**ZONING AMENDMENT
& SUBDIVISION STAFF REPORT****Date: September 17, 2015****APPLICANT NAME**

Springhill & Davenport, LLC

2825 Spring Hill Avenue
(Southeast corner of Springhill Avenue and Davenport Avenue, and Southwest corner of Springhill Avenue and McLean Avenue, extending to the North side of Haas Avenue)

Subdivision approval to create 3 legal lots of record, and Zoning approval to rezone the site from R-1, Single-Family Residential District to B-3, Community Business District, to allow retail sales, a restaurant, and a fire station.

SITE PLAN

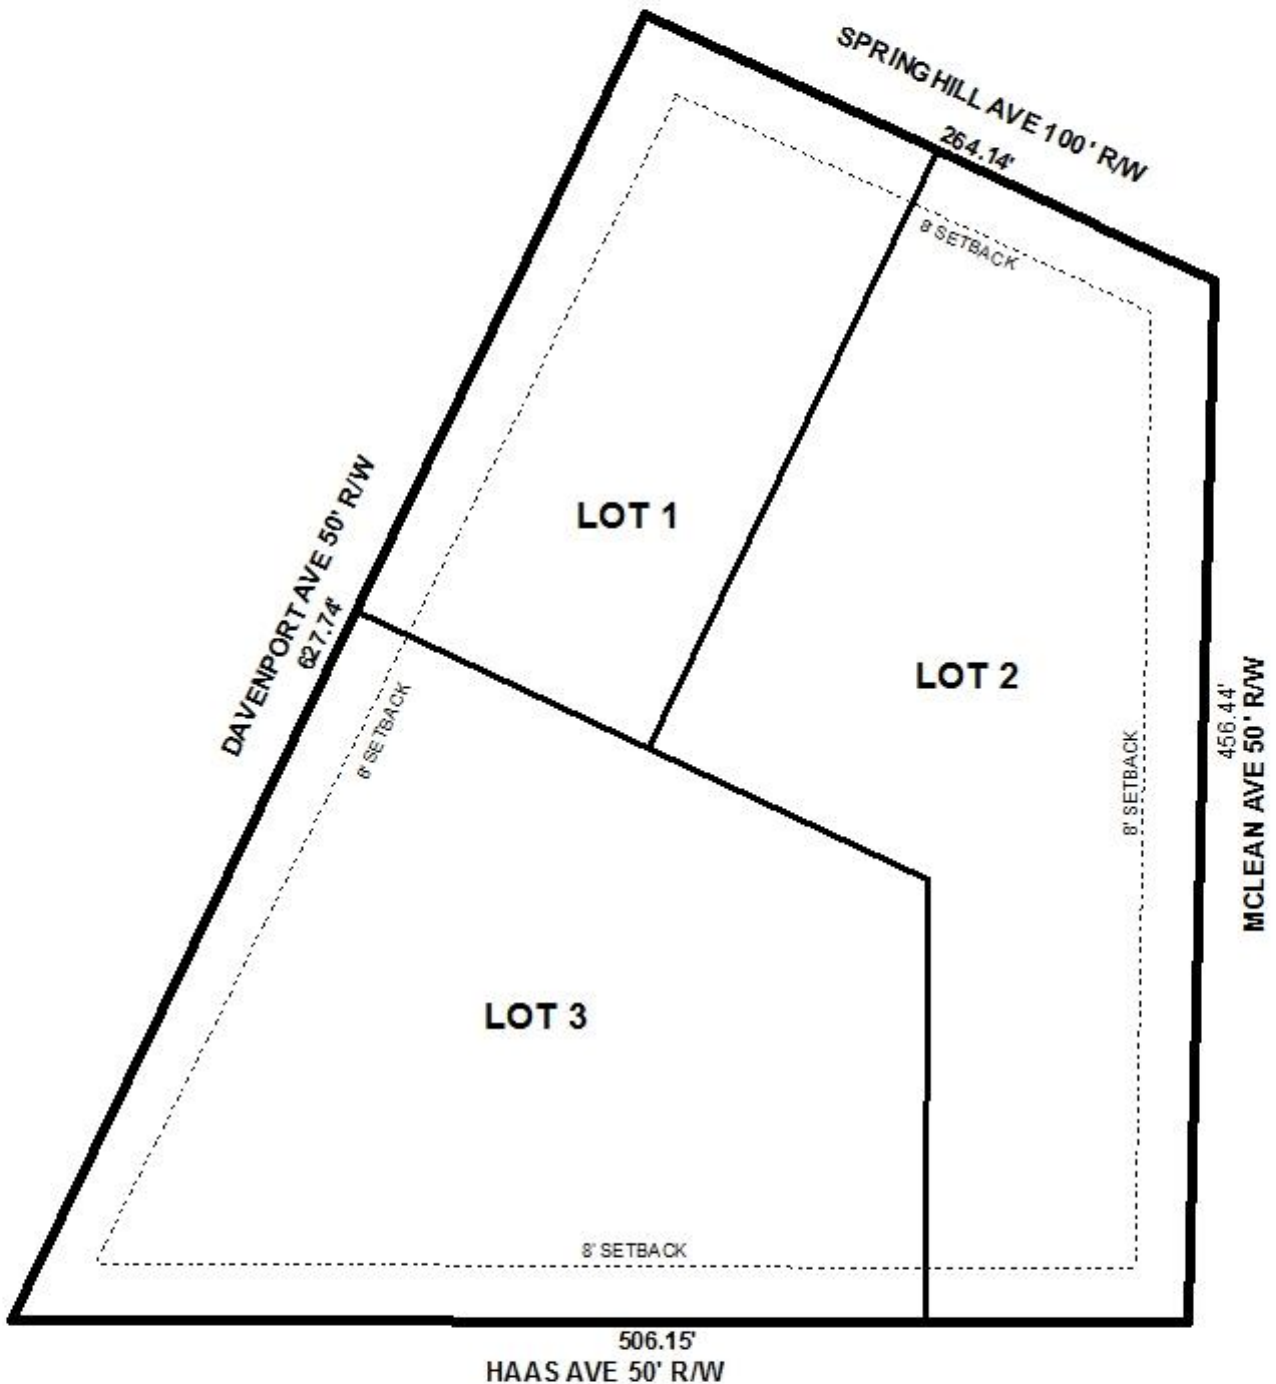
The submitted site plan indicates that the proposed Lots 1 and 2 will have shared access and parking. If the lots will have shared access and parking, an application for an Administrative Planned Unit Development, and approval thereof, will be required prior to the issuance of permits.

While the site plan illustrates sufficient parking for all proposed structures and uses on the site (a total of 108 parking spaces), it should be noted that the applicant incorrectly calculated the parking requirements for a proposed restaurant at 1 parking space per 300 square feet of restaurant, when it should have been 1 parking space for every 100 square feet of restaurant.

No dumpsters are illustrated on the site plan, however it should be noted that any dumpsters on site must be connected to sanitary sewer and have a dumpster enclosure compliant with Section 64-4.D.9. of the Zoning Ordinance. Site plans submitted for permits must illustrate the location of any dumpsters.

It should be noted that while the site plan illustrate several existing trees on site that appear to be proposed as remaining on site, there are no tree planting or landscaped area calculations presented. Development of the site will require full compliance with all tree planting and landscape area requirements of the Zoning Ordinance.
